State of Ohio Environmental Protection Agency

**Re: Storm Water Inspection at Manifold and Phalor / Fairfield County
Permit No: 4GC03132*AG**

Figure 1: Excess sediment around storm drain

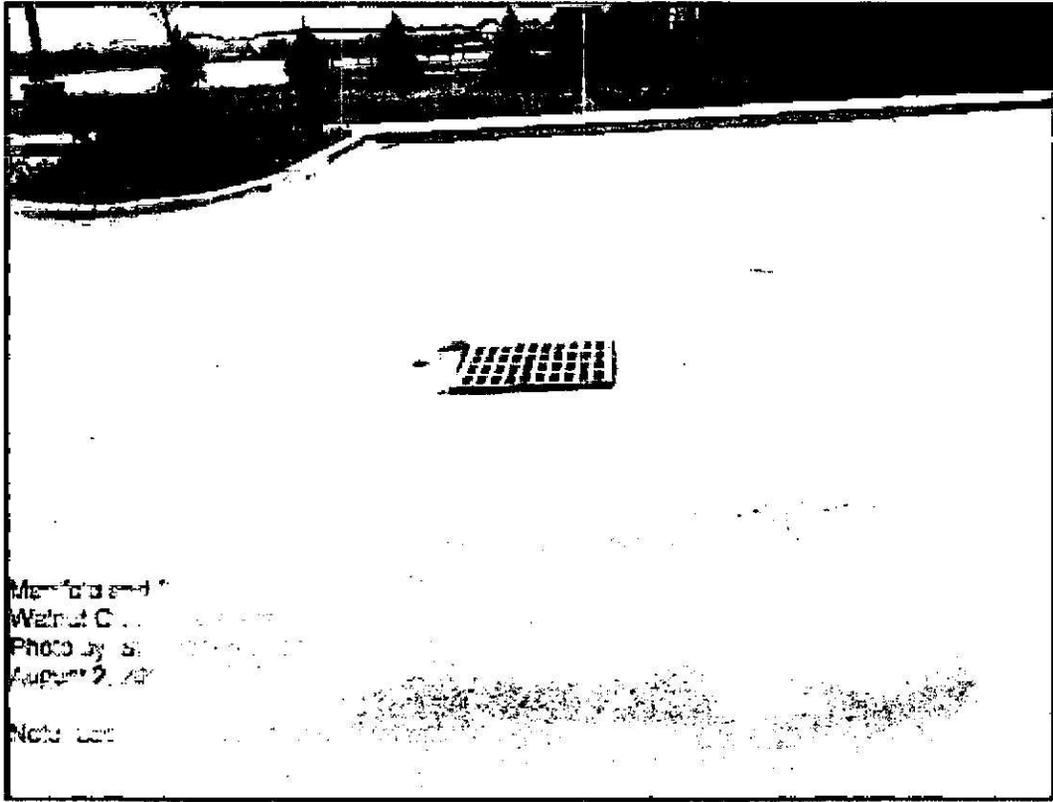
- The excess sediment around the storm drain noted in Figure 1 must be removed.
- Vegetation must be established sufficient to control erosion which is measured by a minimum vegetative density of 70%.
- The General Storm Water Permit requires specific post construction water quality treatment for all sites. Guidance regarding the post construction mandates can be found at:
<http://www.epa.state.oh.us/dsw/storm/CGPPCQA.aspx>. Please submit to my attention (email preferred at harry.kallipolitis@epa.state.oh.us) which practice will be installed at this site to ensure compliance with the General Permit. Please include all design criteria with your submittal.
- A Notice of Termination (NOT) must be submitted once the post construction requirements are verified. The NOT form and filing instructions can be found at:
<http://www.epa.state.oh.us/dsw/storm/stormform.aspx>.
